Dr. Víctor Hugo Alcocer
Subdirector General Técnico
Comisión Nacional del Agua (CONAGUA)
Ave. Insurgentes Sur No. 2416
Col. Copilco – El Bajo
Del. Coyoacán CP 04340
Ciudad de México,
México

Subject: Technical Letter: Opinion Regarding Options 6.1 and 6.2 for the *Centro de Gestión de Residuos Sólidos en el Bordo Poniente*

Figure 1. Location of Option 6.1 and Option 6.2 (CONAGUA’s latest data)

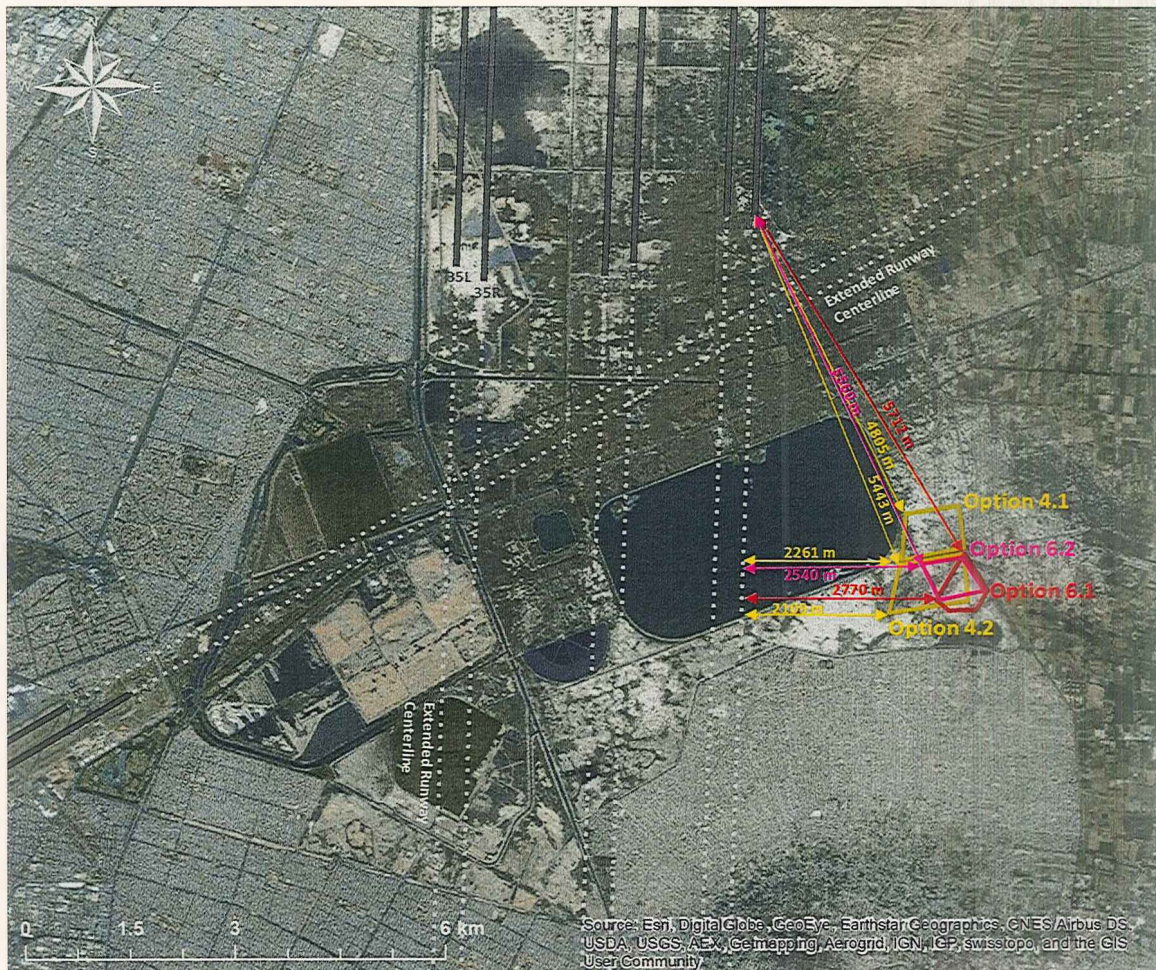
Figure 1 shows the location of Option 6.1 (in red color) and Option 6.2 (in purple color) in relation to NAICM and AICM, as well Option 4.2. (Option 4.1 is shown for reference purposes only.) Table 1 and Table 2 provide the coordinates and ground elevation of Option 6.1 and Option 6.2, respectively, as provided by CONAGUA most recently.

Again, based on the ground elevation at Option 4.2 utilized by MITRE in its previously-conducted assessments (i.e., 2223.82 m above MSL), **the elevation of 40-meter-high smokestacks at Option 6.1 or Option 6.2 should not exceed 2263.82 m above MSL.**
